CITY PLANNING COMMISSION
1231 "I" STREET, SUITE 200, SACRAMENTO, CA 95814

LOCATION: 2541 21st Street

PROPOSAL: The applicant is requesting the necessary entitlements to rezone 6.8± developed acres from C-2 and R-4 to OB-R to allow the Bishop Monogue School to be converted to office use and to allow the construction of a new 38,300 square foot office building.

APPLC. NO. P91-034

EXHIBIT A
SITE PLAN

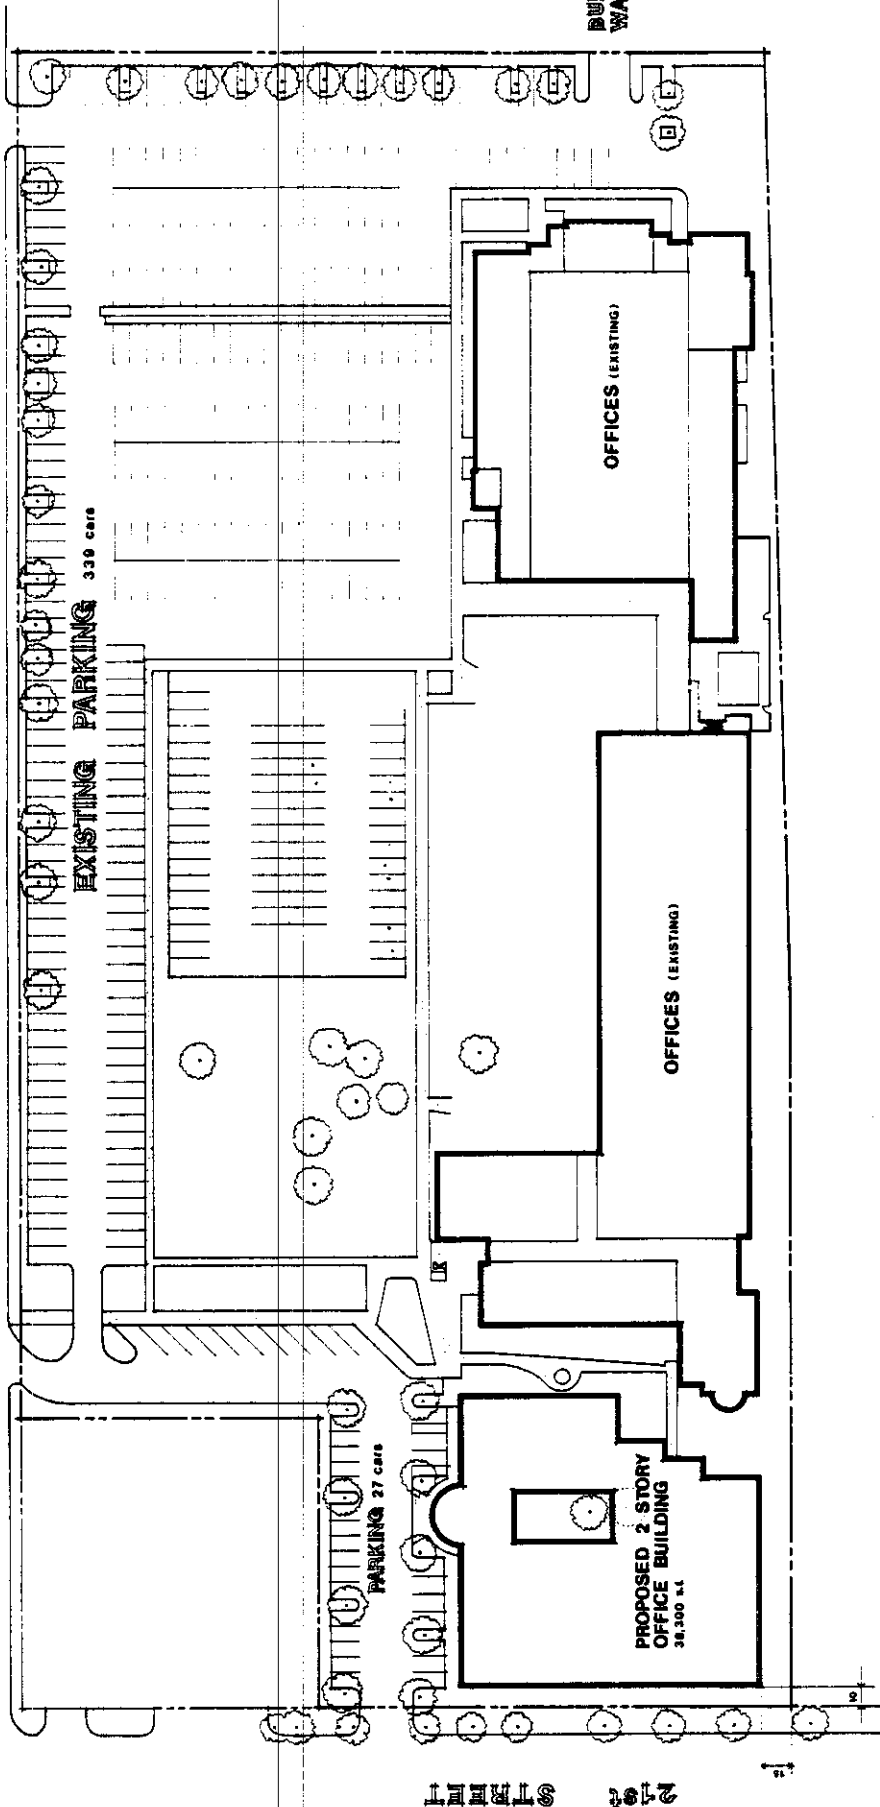
The proposed Bishop Manogue office project is not "pedestrian-friendly". It proposes a long stretch of parking lot adjacent to Broadway. The project seems to include little or no new landscaping. From what we can tell, the new building will be a tilt-up concrete building with some brick tile veneer and aluminum windows with tinted glass. Another tilt-up office building and parking lot is not likely to contribute to the enhancement of Broadway as a retail commercial/ entertainment corridor.

not necessary for the on-site office workers; and, the storage of vehicles of any kind would not be a permitted use in the O-B zone. Staff recommends that the tennis courts be retained as a recreational component of the project and not be converted to parking or storage. At this time, any parking above the 251 spaces would be contrary to the City Council's adopted interim parking regulations. Other parking regulations will need to be followed such as those pertaining to tree shading, surfacing, parking space dimensions, etc.
